Product Change Notification

Date Issued :	October 14, 2026	**PCN Number :**	518872
Reason for Change :	Change to Product		
Description of Change :	Correction of a typo in the SD. This change does not affect product design, dimensions, fit, form, function, reliability, or performance.		
Assessment of Change :	No change to parts - Form/Fit/Function		
Planned Implementation Date :	April 16, 2027		
Customer Sample Availability Date:	October 16, 2026

【Change Overview】

RECOMMENDED P.W.BOARD PATTERN LAYOUT (REFERENCE)
(SM OPENING DIMENSION)

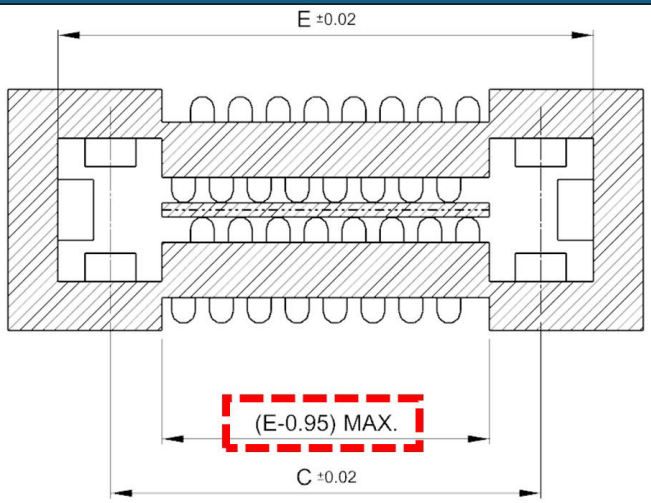
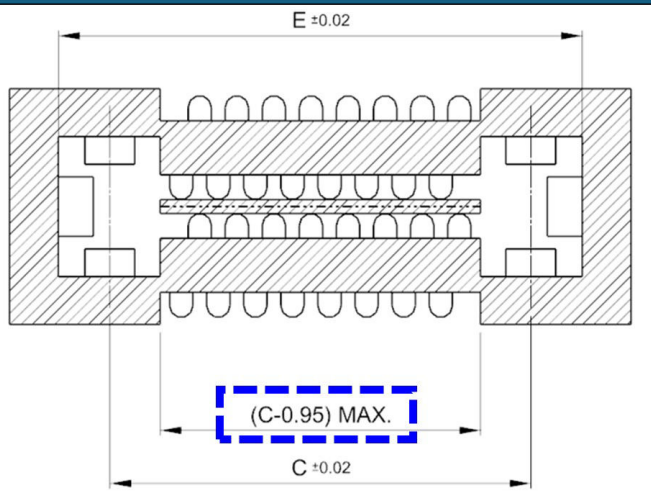
Correction of a typo only in the recommended P.W. board pattern layout in the SD. This change does NOT affect the actual product's design, dimensions, fit, form, function, reliability, or performance.

Before "(E-0.95)MAX." is incorrect dimension	After "(C-0.95)MAX." is correct dimension
